To: Docketing Division
From: George Martin, Grade Crossing Planner, Rail Division
Re: In the matter of the authorization of Wheeling & Lake Erie Railway to install an active grade crossing warning device in Stark County
Date: August 26, 2013

TO: Randall Schumacher, Supervisor, Rail Division, PUCO
FROM: Cathy Stout, Manager, Safety Section, ORDC
BY: Mike Forte', Project Manager, ORDC *MDF*
SUBJECT: Tuscarawas Street, WLE, Village of Navarre, US DOT 474 327G
DATE: August 20, 2013

Re: Grade Crossing Warning Project
Tuscarawas Street, Village of Navarre
US DOT 474 327G

Field Sketch

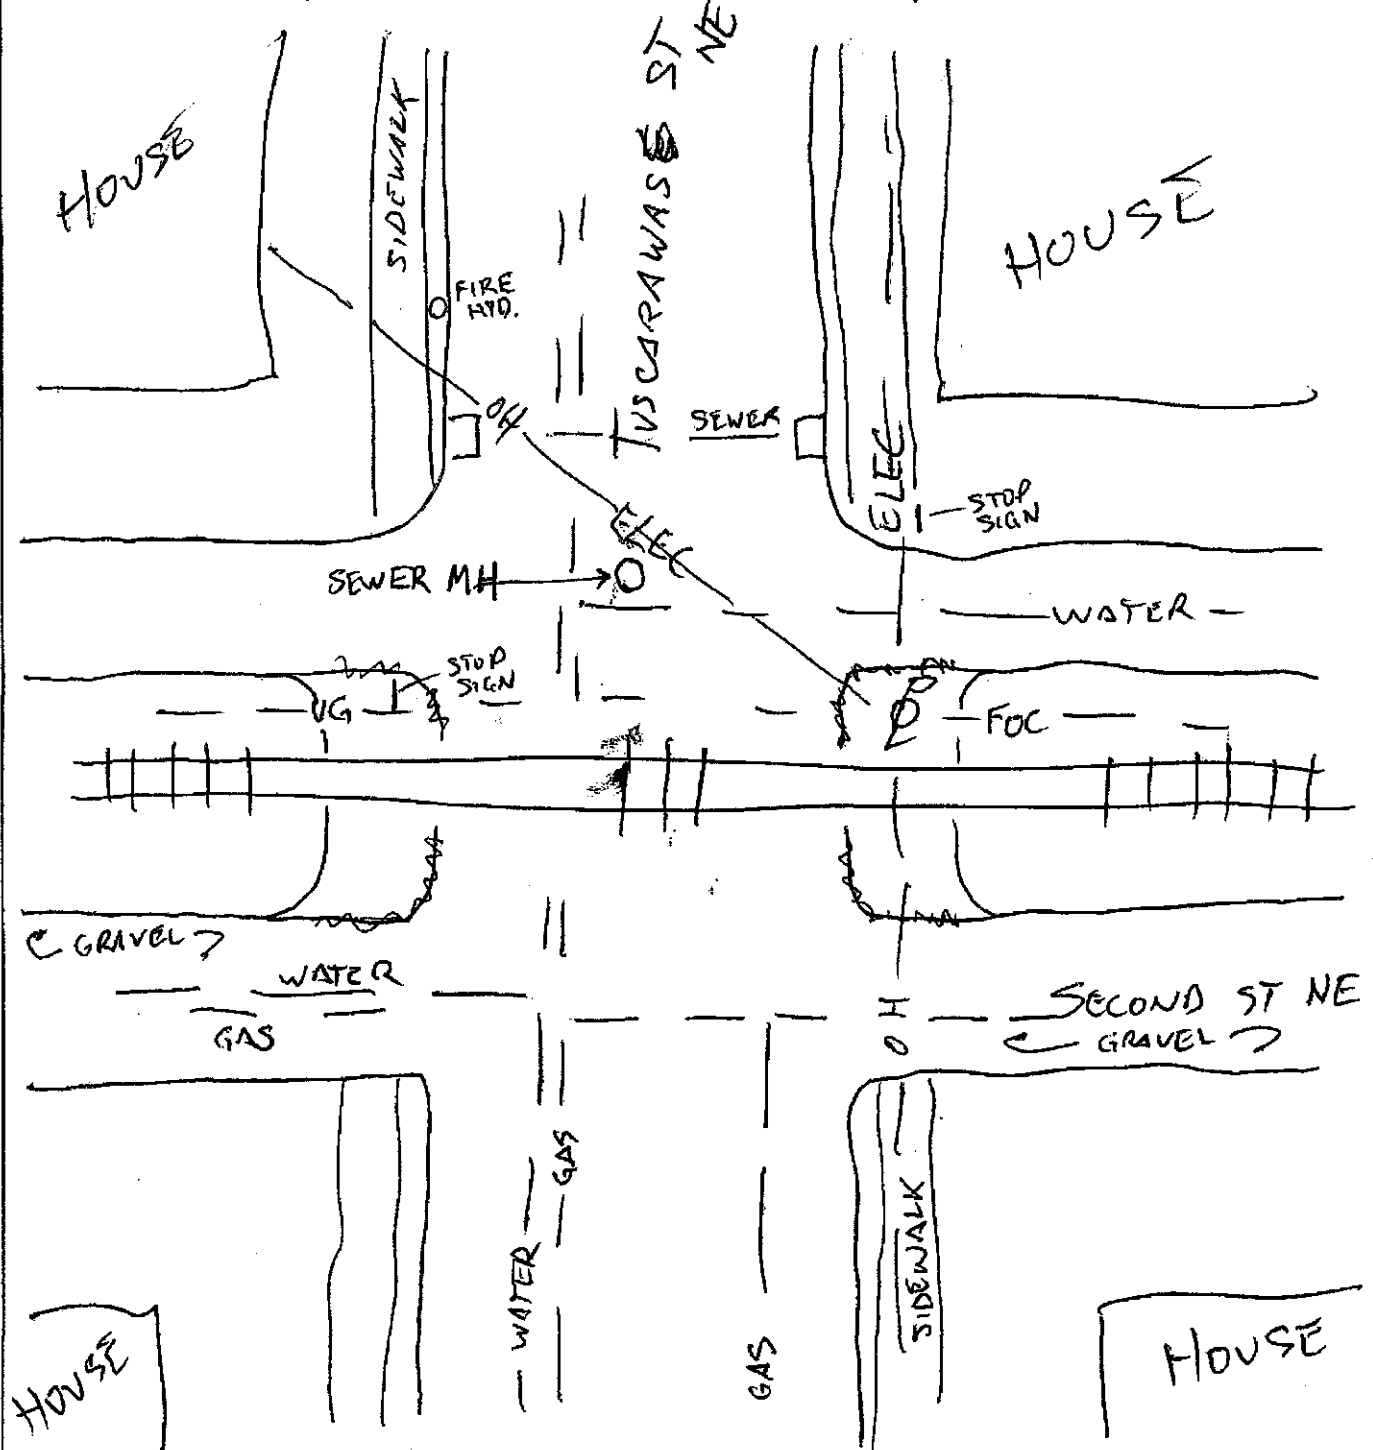
Diagnostic Team Recommendations	
	Quadrants Needed
<input type="checkbox"/> Install/upgrade active devices	
<input type="checkbox"/> Automatic Flashing Lights (AFLS)	
<input type="checkbox"/> AFLS / Cants	
<input checked="" type="checkbox"/> AFLS / Gates	SE NW
<input type="checkbox"/> AFLS / Gates / Cants	
<input checked="" type="checkbox"/> Bells / number	2 - SHUT OFF WHEN GATES HORIZ.
<input type="checkbox"/> Upgrade circuitry / type	
<input checked="" type="checkbox"/> Sidelights	4 ALL ST 2ND ST APPROACHES
<input checked="" type="checkbox"/> Guardrail Needed	
<input checked="" type="checkbox"/> Install/Replace curb	
<input type="checkbox"/> Bungalow placement & offset from rail & highway	AS DETERMINED BY WLE
<input checked="" type="checkbox"/> Other (define) STREET SIGN LOCATIONS	
Comments: NW - IN SIDEWALK WITH GUARDRAIL AND MODIFICATIONS TO SIDEWALK AND 2ND. SE - CURB ISLAND IN STREET	
<input type="checkbox"/> Install/upgrade traffic signal preemption

<input type="checkbox"/> No improvements needed	
<input checked="" type="checkbox"/> Other (define) NOM NO CURB, & MUTED VARIANCES	
Acknowledgement of Recommendations (each entity represented at the diagnostic must have at least one signature acknowledgement): <div style="display: flex; justify-content: space-between;"> <div> M. Fori Cathy Stout Dan Reinsel </div> <div> Jeffrey C. Seward  </div> </div>

ALL ABOVE ITEMS WILL BE REVIEWED AFTER PRELIMINARY SITE PLAN OPTIONS ARE SUBMITTED.

SHEET 4:
GATES POSITIONED TO SERVE
TUSCARAWAS STREET WITH SIDE LIGHTS
FOR ALL FOUR ALLEYS MOUNTED ON
GATE MASTS. GUARD RAILS INSTALLED
OUT INTO ROADWAY AROUND THE GATE
ASSEMBLIES. SIDEWALK PATHWAYS
REMAIN AS IS. OVERALL ROADWAY
WIDTH REDUCED TO JUST OVER 19
FEET.

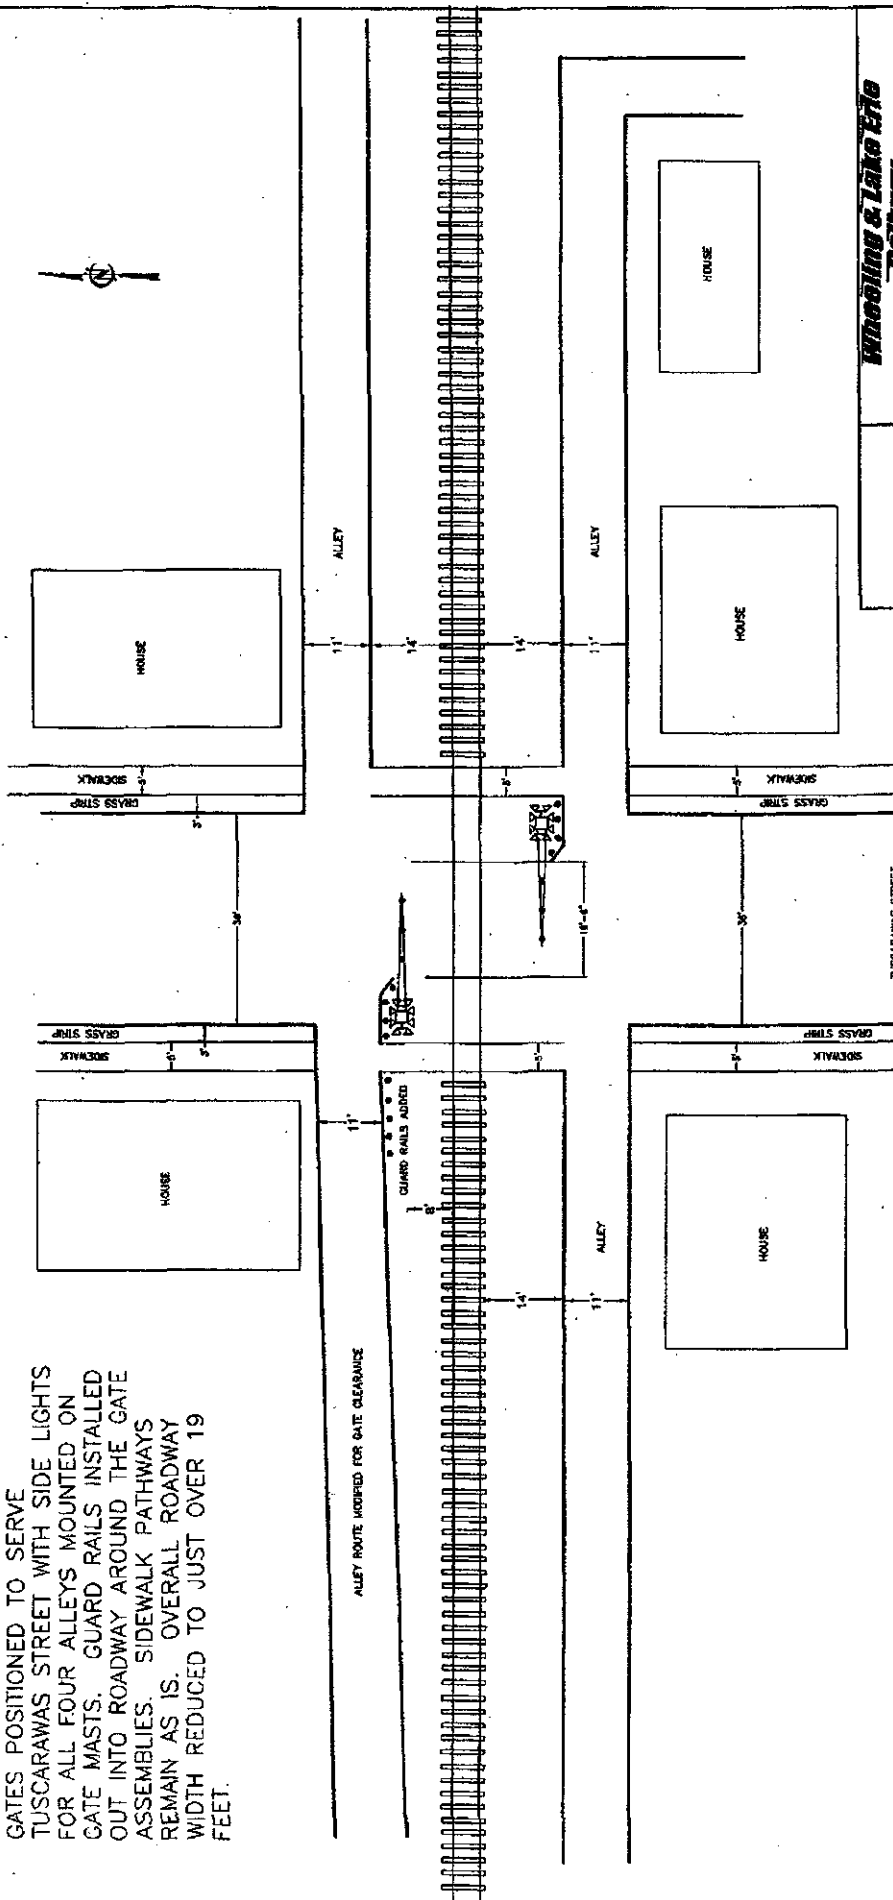
PROJECT DESIGN WILL CONFORM TO OPTION 4,
MDF 11-8-12
